# CITY OF ALBUQUERQUE

DEVELOPMENT REVIEW BOARD--SPEED MEMO

**DRB CASE NO/PROJECT NO: 1002520**

**RE: Villa de la Cueva/final plat**

ENGINEER'S SEAL	VILLA DE LA CUEVA	DRAWN BY MCHW
	WALL DESIGN EXHIBIT	DATE: 04
	 Rio Grande Engineering 3800 COMMACHE ROAD NE	APP-111-DR-6-15-04
		SHEET 1

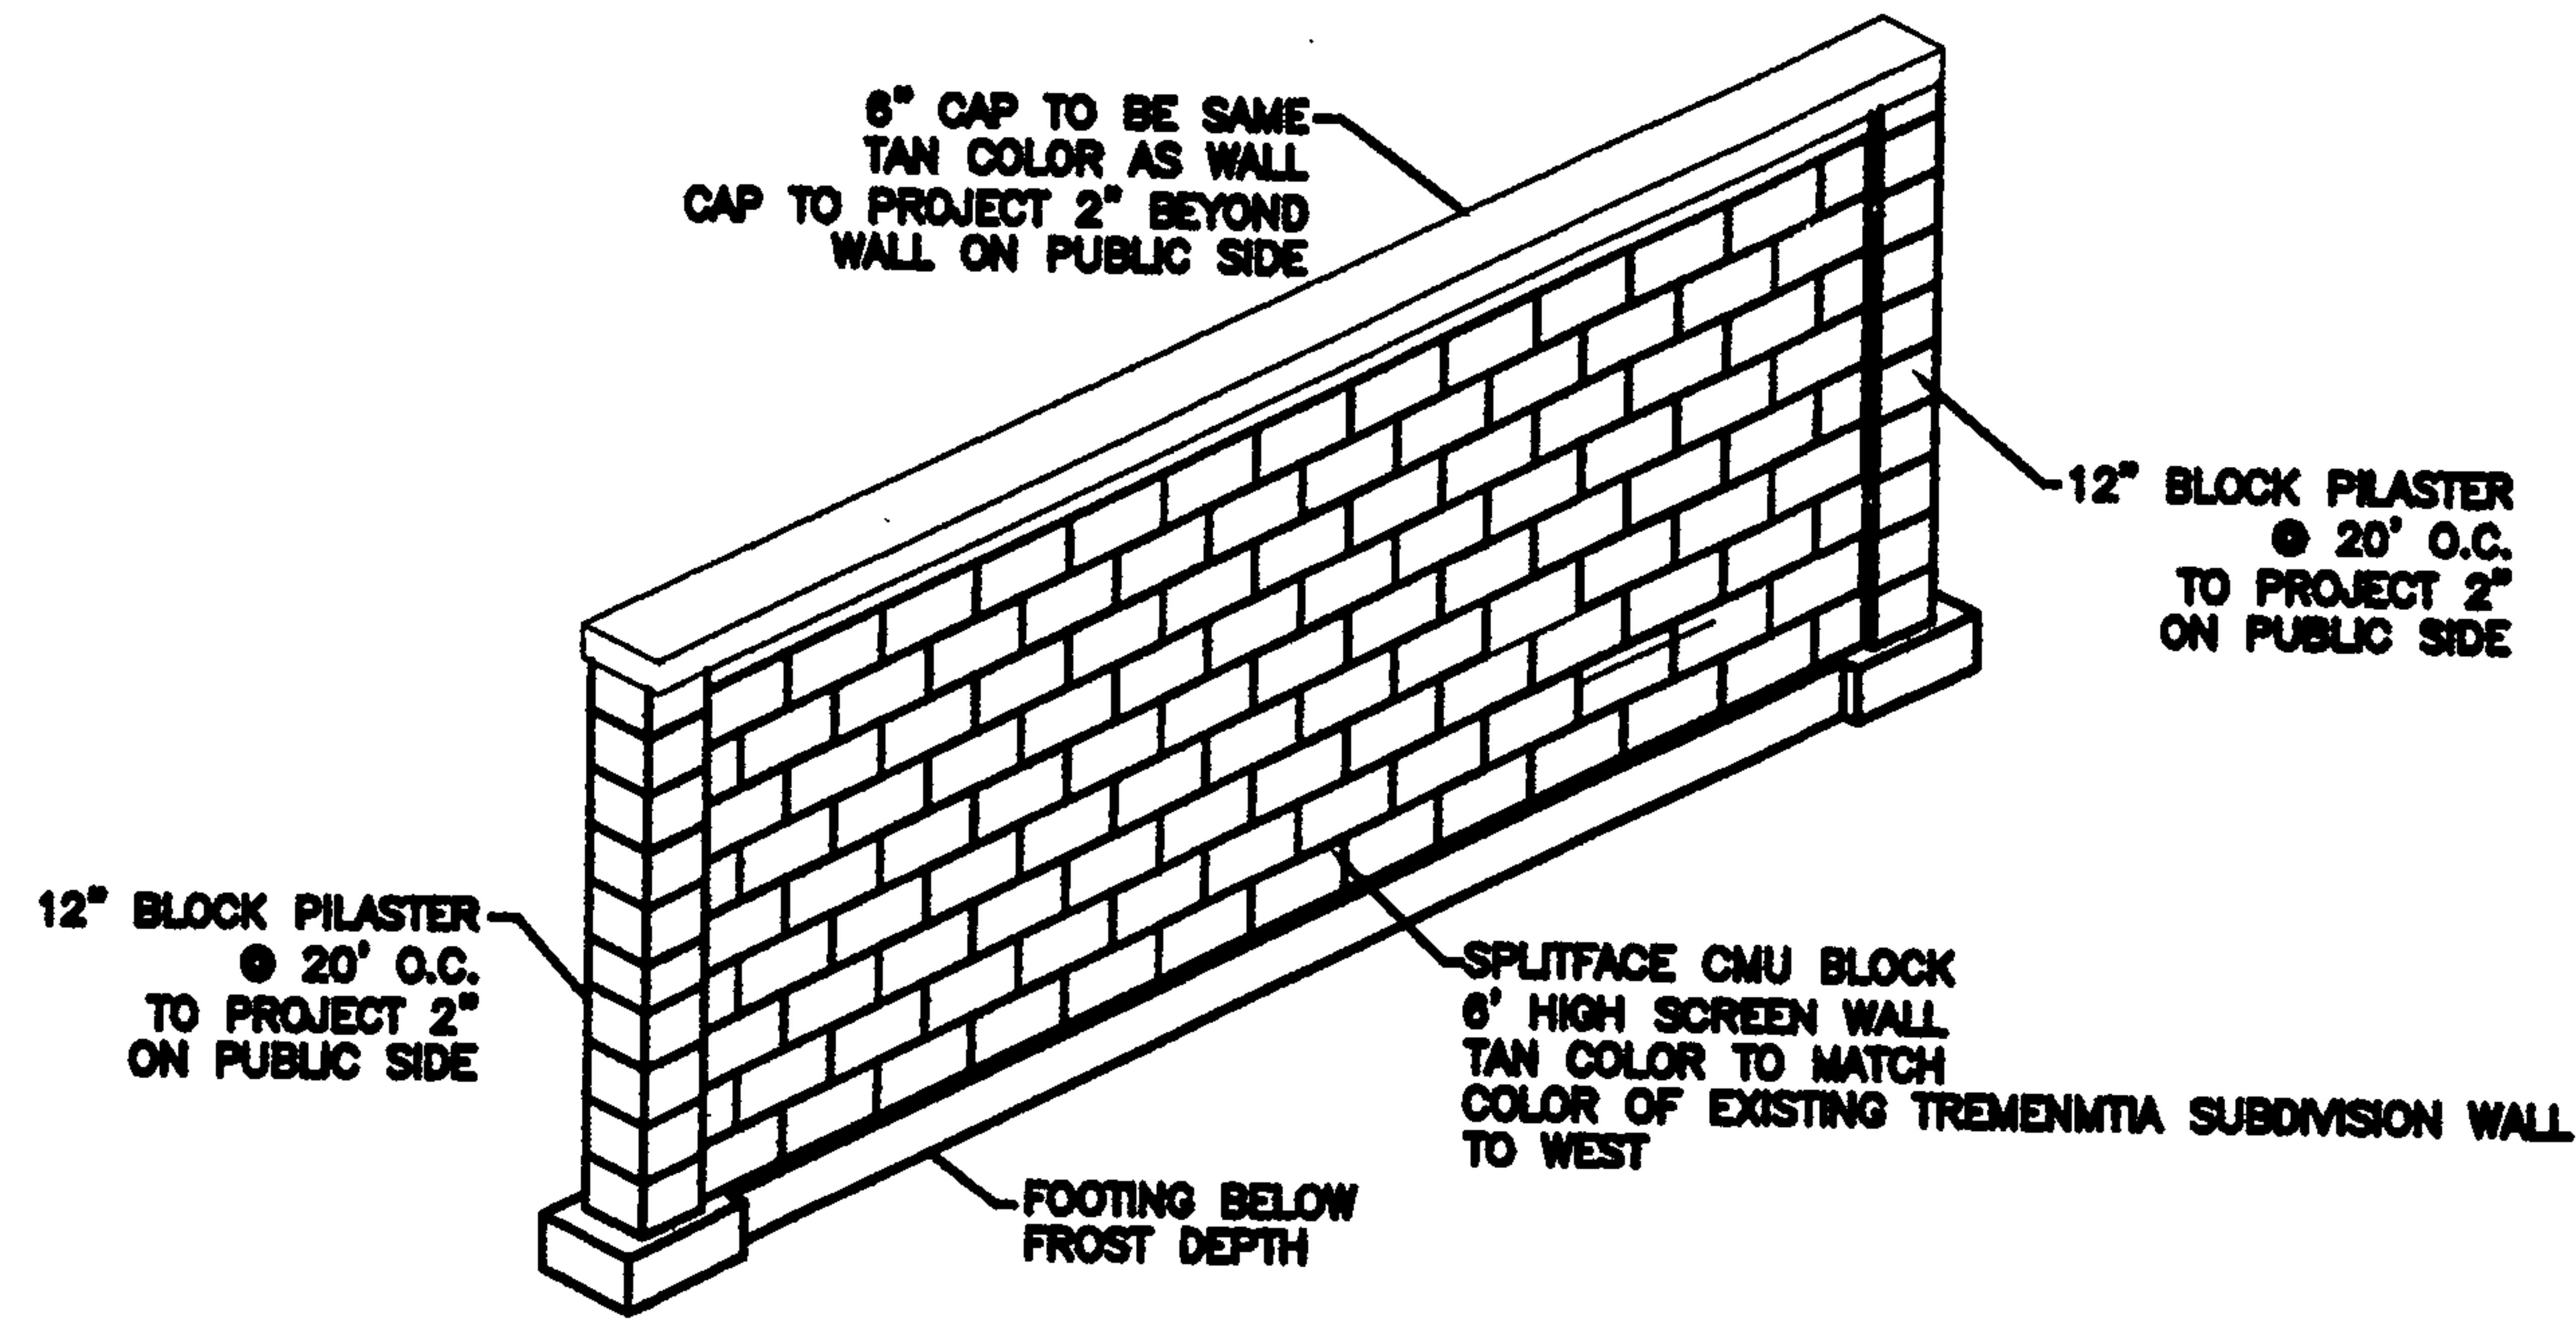
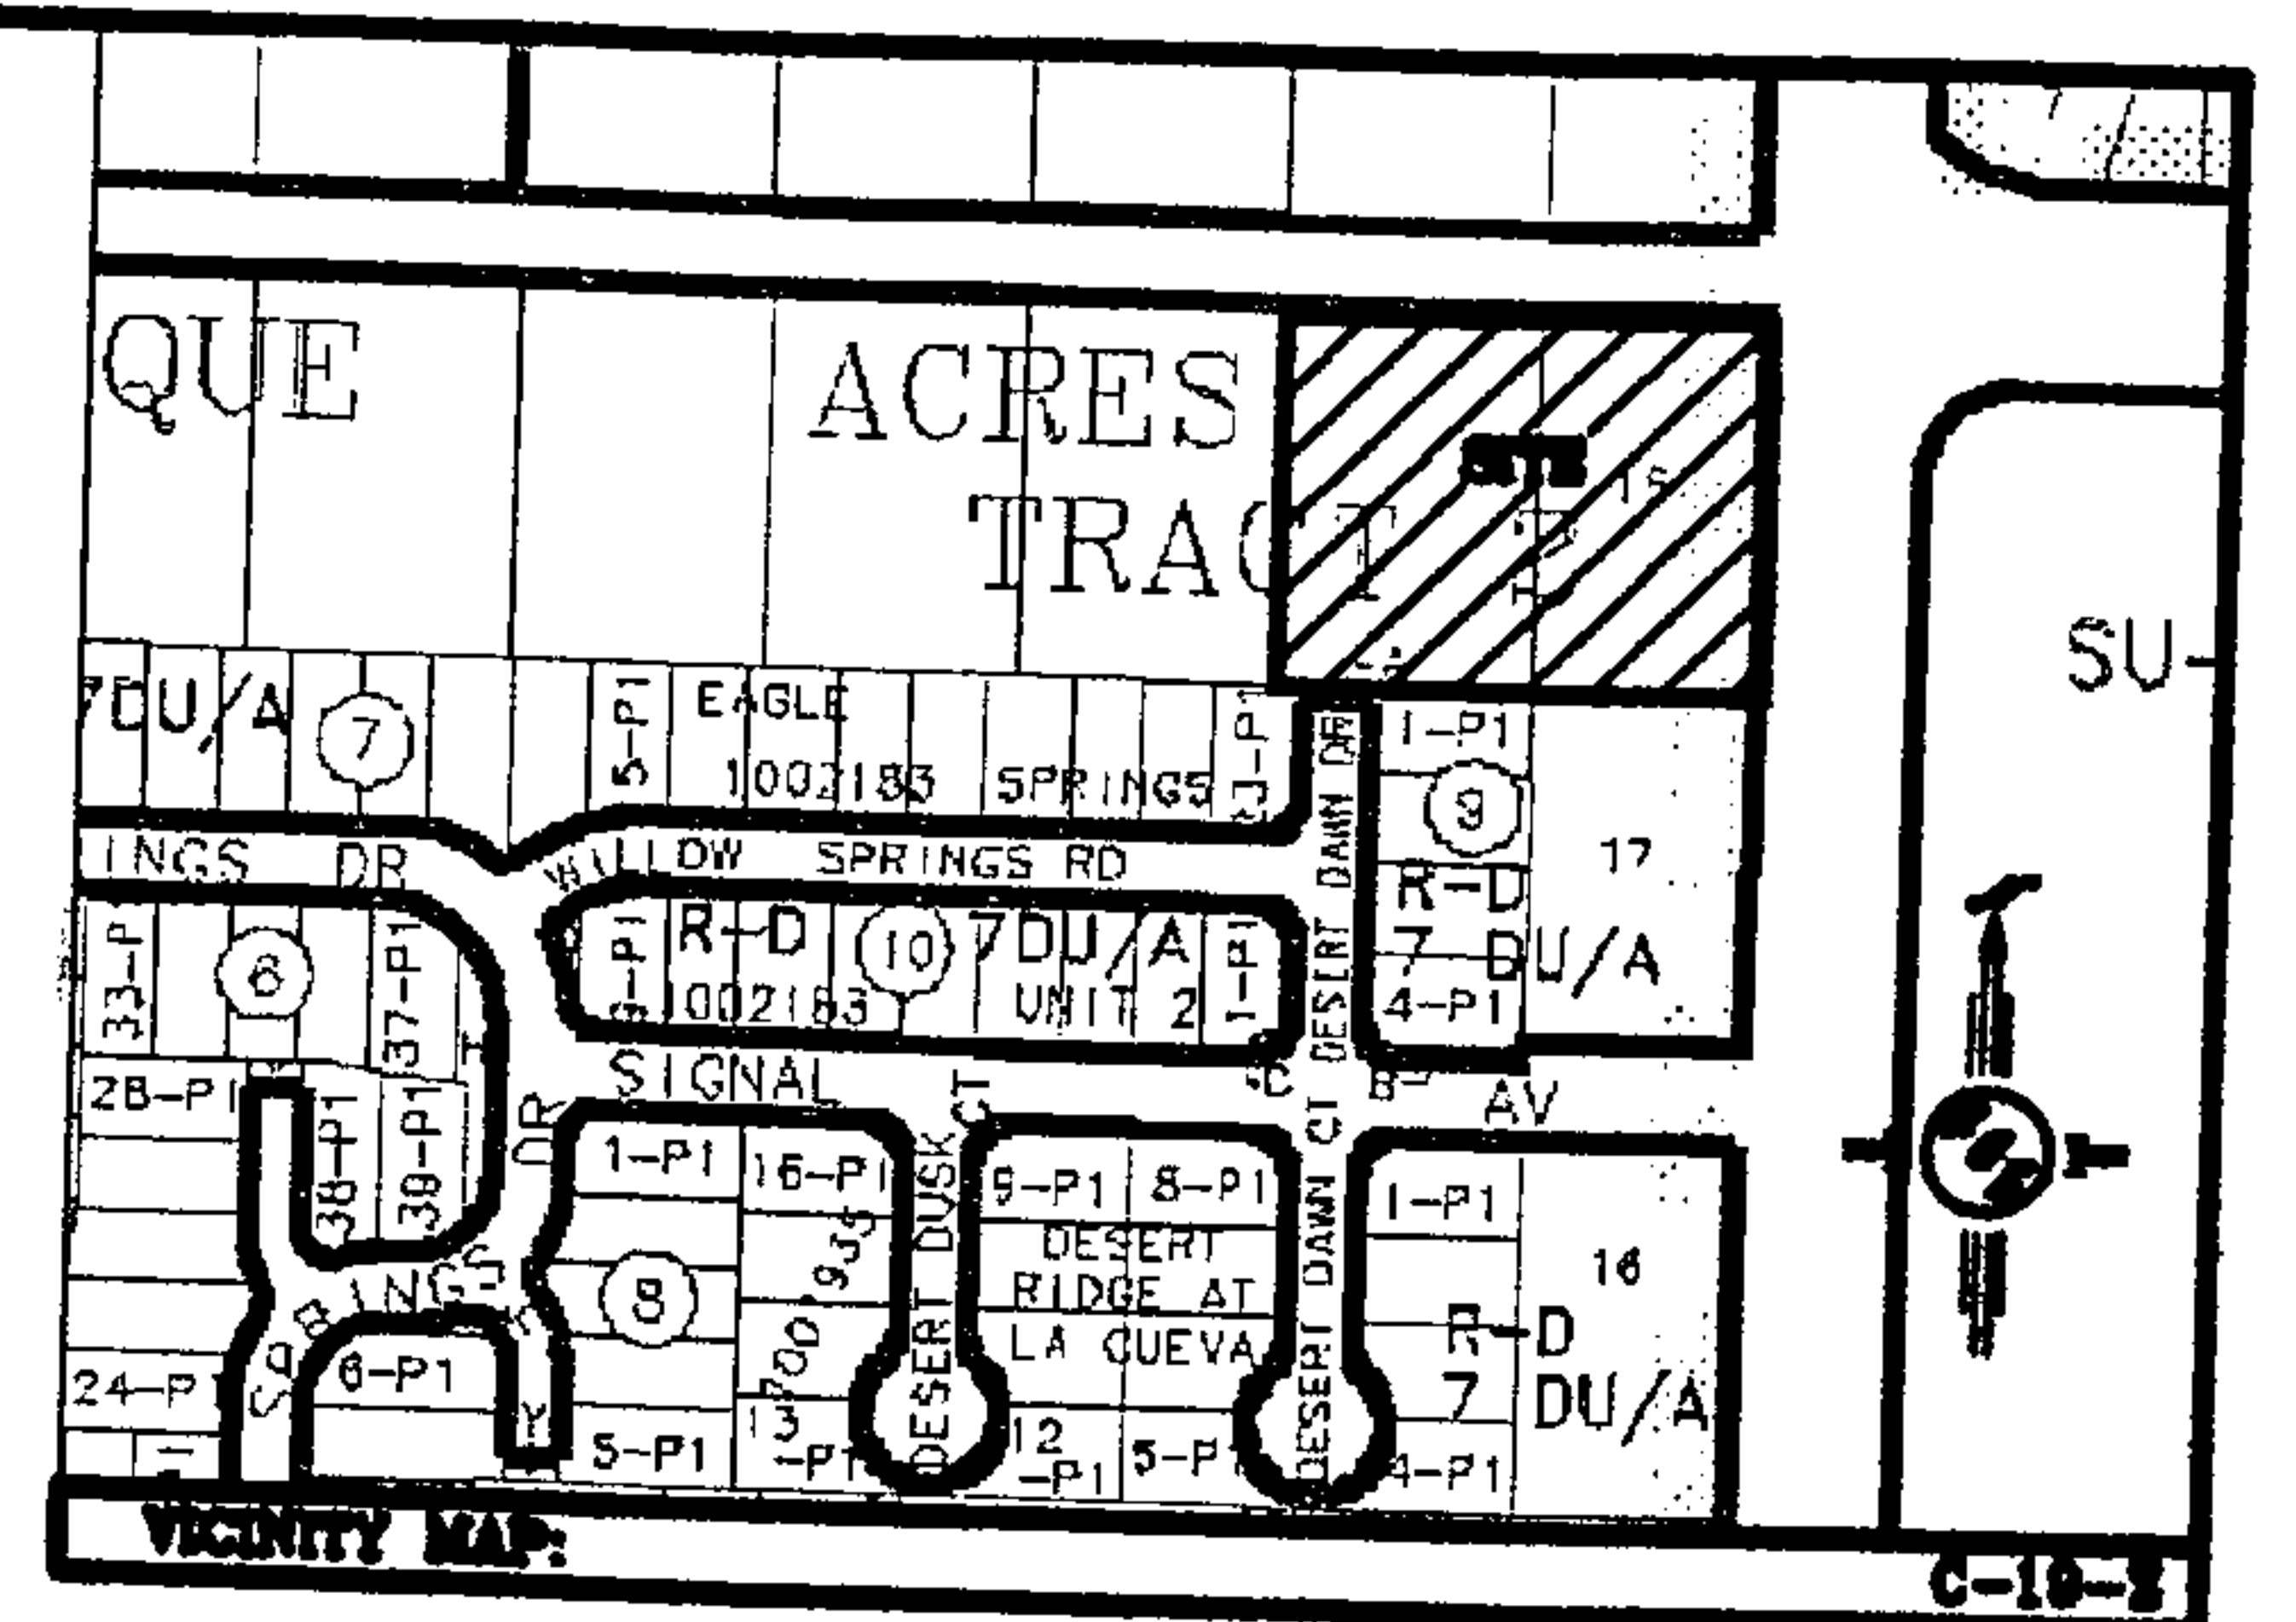
PLANNING (Last to sign): AGIS dx  
Wall design - one correction  
 \_\_\_\_\_  
 \_\_\_\_\_  
 \_\_\_\_\_

- Cuevita Court must be labeled right in/right out only.
- No direct access to Wyoming or Alameda is allowed.
- Wall design submittal shall be revised to reflect Zone Code requirements.

Wall design submittal shall be revised to meet Zone Code requirements.

Perimeter Wall Approved  
*Sharon Watson*  
 DRB Chair  
 10/8/04  
 Date
